UNITED STATES PATENT AND TRADEMARK OFFICE

Office Action Summary

09/994,049

DETAILED ACTION***Continued Examination Under 37 CFR 1.114***

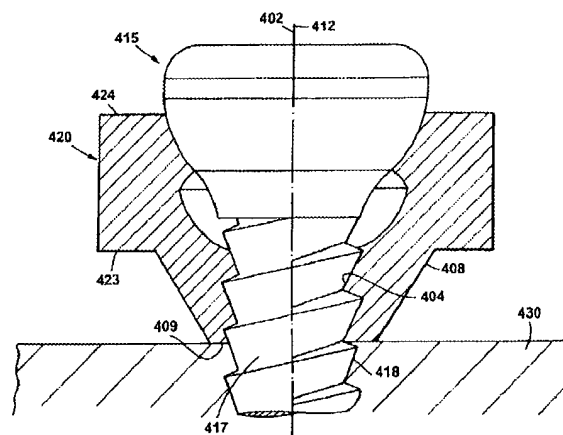
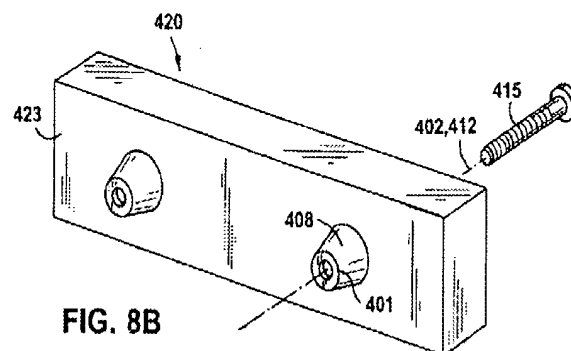
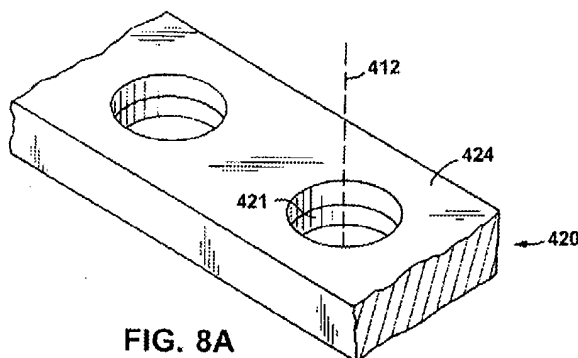
Klaue et al. disclose a system comprising a bone plate 420 and a bone screw 415. The bone plate comprises an upper surface 424, a bone-contacting surface 423, a plurality of holes 421 extending through the upper and bone-contacting surface. The holes are dimensioned and configured to receive the bone screw 415. At least one of the holes 421 includes an annular protrusion 401 disposed on the bone-contacting surface and at least surrounding the hole (see Figure 8B, below).

The bone plate defines a nominal plate thickness in regions between the holes and the protrusion 401 defines an increased plate thickness that is greater than the nominal plate thickness (see Figure 9, above). Figure 9 shows that the increased plate thickness appears to be *about* 1.5 to about 2 times greater than the nominal plate thickness. The protrusion minimizes contact between the bone-contacting surface and a bone (see Figure 9, above, and col. 5, lines 37-40). The hole defines a central axis and the protrusion 401 tapers radially inward with respect to the central axis in a direction from the upper surface 424 toward the bone-contacting surface. The bone plate also includes an indentation in the upper surface 424 opposite from the protrusion 401 (see Figure 9, above). The indentation is substantially concentric with the protrusion. Figure 9 suggests that the protrusion tapers radially inward and defines a taper angle of about 40° to about 100°. The hole is provided with internal threads. The bone plate defines a longitudinal axis and the plurality of holes are spaced apart along the longitudinal axis. Klaue et al. disclose the claimed invention except for the threaded holes being tapered radially inward with threads from the upper surface to the lower surface and the screw head having threads complementing with the threaded taper holes.

Fig.1

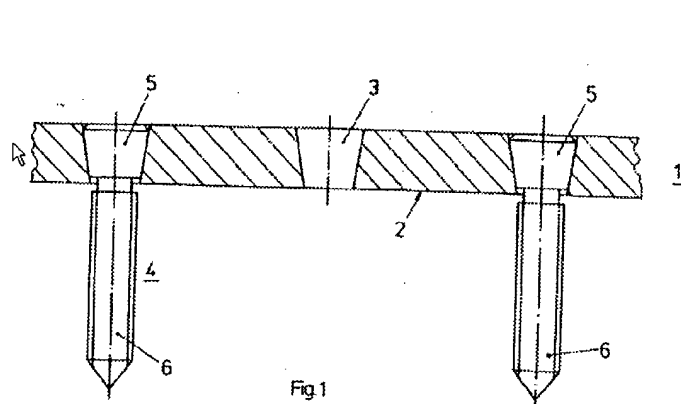
Frigg, et al. disclose a bone plate with threaded holes having threads from an upper surface to a lower surface and bone screws with heads (see Figures 1-3, next page), wherein the holes are made taper and the heads of the bone screws are made taper and with threads to complement with the threaded taper hole in order to ensure optimal locking between the bone screws and bone plate when the bone screws are used in affixing the bone plate (see page 1, lines 10-13).
